## DEVELOPMENT APPLICATION ASSESSMENT REPORT

<b>Application Number:</b>	DA2023/0707
----------------------------	-------------

<b>Responsible Officer:</b>	Jordan Howard
<b>Land to be developed (Address):</b>	Lot 81 DP 866452, 2 Manor Road INGLESIDE NSW 2101
<b>Proposed Development:</b>	Alterations and additions to a dwelling house including a carport and secondary dwelling
<b>Zoning:</b>	RU2 Rural Landscape
<b>Development Permissible:</b>	Yes
<b>Existing Use Rights:</b>	No
<b>Consent Authority:</b>	Northern Beaches Council
<b>Delegation Level:</b>	DDP
<b>Land and Environment Court Action:</b>	No
<b>Owner:</b>	John Arthur Vumbaca Esterina Vumbaca
<b>Applicant:</b>	John Arthur Vumbaca

Figure 1 - Extract of Section A-A (Drawing No. 2-2 1008 22, Issue 3, dated 6 February 2024) depicting building height.

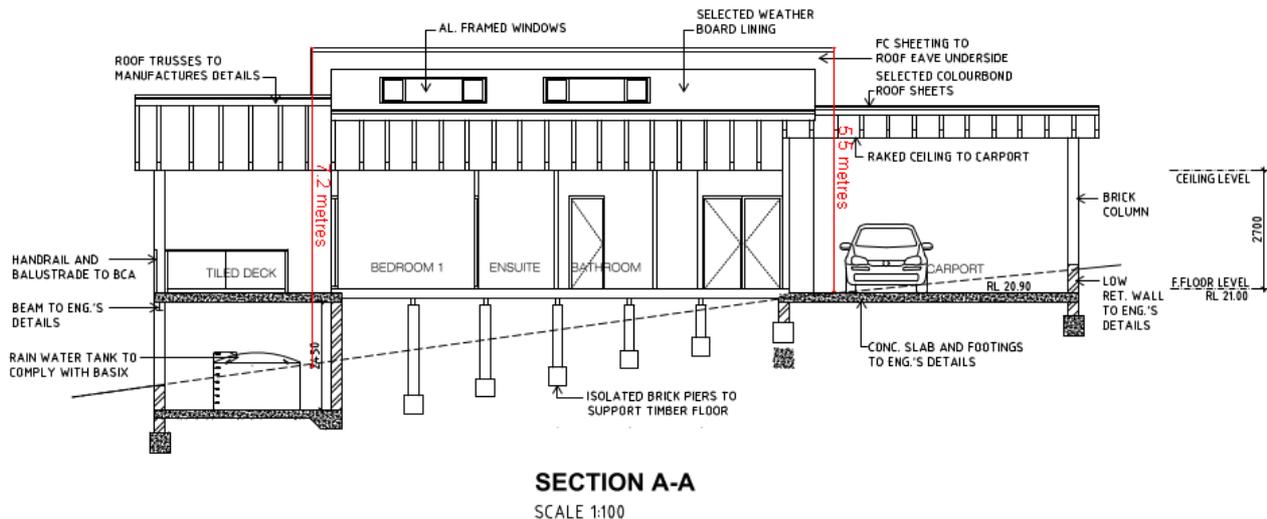
Development standard:	Height of buildings
Requirement:	5.5m
Proposed:	7.2m
Percentage variation to requirement:	30.9%

The location chosen at the subject site is sloped, and the 5.5m height of buildings standard that specifically applies to detached secondary dwelling on rural land does not provide much tolerance for working with sloped topography. Given the floor space restrictions on secondary dwellings, and preference for single-storey secondary dwellings outline the P21DCP, it would not be reasonable to require a two-storey stepped secondary dwelling to accommodate for slope. Excavation would also be unfavorable. As such, the proposed development is considered to respond sensitively to the natural topography.

The submitted written Clause 4.6 variation request is considered to be well founded having regard to the circumstances of the development and it is therefore considered appropriate that in this instance, flexibility in the application of the height of buildings development standard be applied. In this context the proposal meets the Objects of the Environmental Planning and Assessment Act 1979, contained in Section 1.3, having considered the relevant provisions under s.4.15 of the Act. Consequently, the development is considered to be in the public interest, subject to conditions.
